## SERVICE ACTION: LEFT SIDE DOORS MAY NOT OPEN FROM OUTSIDE

F34 (3 Series Gran Turismo)	F36 (4 Series Gran Coupe)	Produced from October 5, 2015 to October 23, 2015
-----------------------------	---------------------------	---

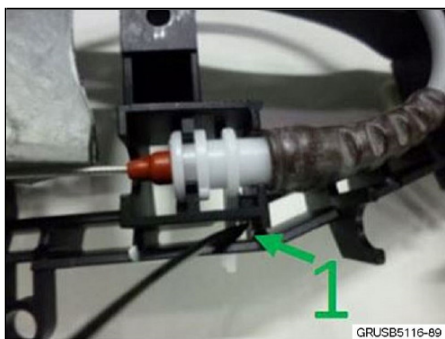
Left side doors (front and/or rear) may not be able to be opened from the outside.

Bowden cable may twist and come loose from the bracket on the outside door handle support.

Secure the Bowden cable with straps to prevent twisting on both left side (driver's side) doors.

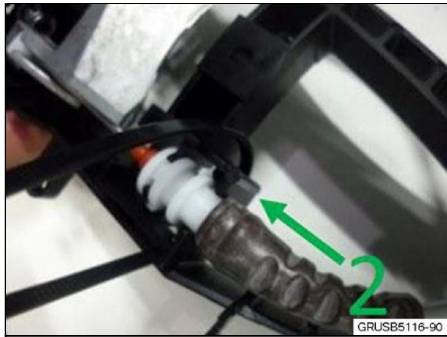
1. Remove the **front left** outside door handle support as described in repair instructions **RA 51 21 125 "Removing and installing/replacing the left or right outside door handle support with lock barrel"**.
2. Insert small end of cable strap into door handle support while ensuring that Bowden cable is seated correctly (See Figure 1)

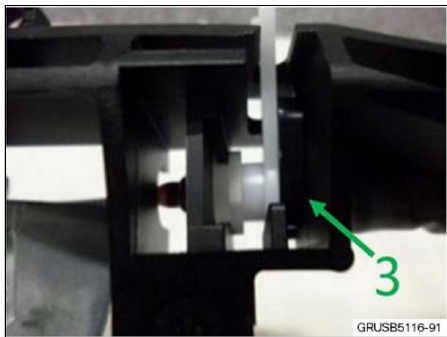
3. Loop over door handle support as shown (in Figure 2).

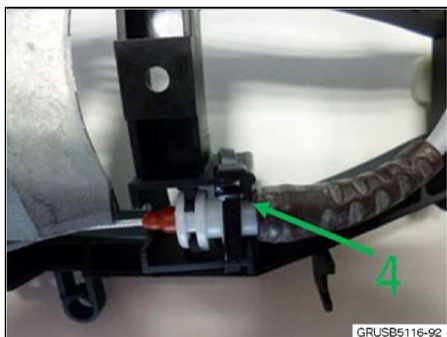
4. Make sure cable strap is secured and Bowden cable is seated securely as shown (in Figure 3).
